Staff Report to the Zoning Administrator

Application Number: 08-0139

Project Description: Proposal to construct a 2nd-story addition to include 3 bedrooms, two bathrooms, closets and a stairway to an existing 1-story single family dwelling with a basement to result in a 2-story, 5 bedroom, 6 bathroom single family dwelling. The project requires a Coastal Development Permit and a Residential Development Permit to construct an addition greater than 800 square feet to an existing nonconforming structure.

3 NORTH ELEVATION (SIDE VIEW)

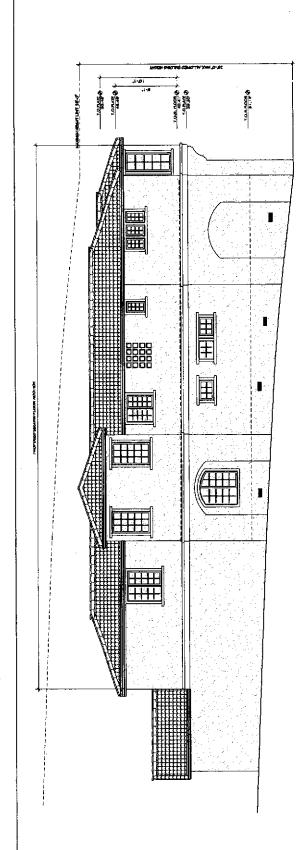
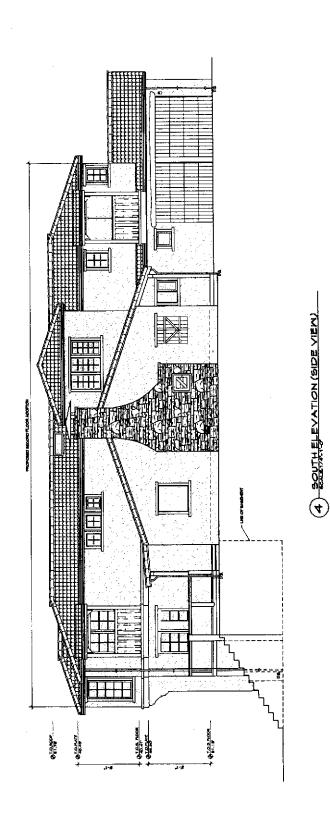
The Urban Designer had originally concluded that the findings for neighborhood compatibility could not be made because the building addition did not provide enough visual relief on the north wall of the second story and that it presented a relatively severe façade to the property to the north. The large bow window also added to the massing facing the beach. The Urban Designer suggested design alterations to address the north wall and reduce the bow window.

The applicant submitted a revised project design to address these comments. The project now complies with the recommendations of the Urban Designer in that the wall plane on the north side has been provided additional design treatment including a belly band detail located between the first and second floor, divided windows consistent with the windows throughout the existing dwelling, an additional wall extension similar to the one shown on the original plans, and a hipped roof on the east end of the building. These design features articulate the north wall plane and create an elevation more consistent with the overall character of the building, which unifies the overall building design. Furthermore, the beach elevation has also been modestly scaled back in size, provided brackets, a belly band, and divided windows consistent with the existing dwelling.
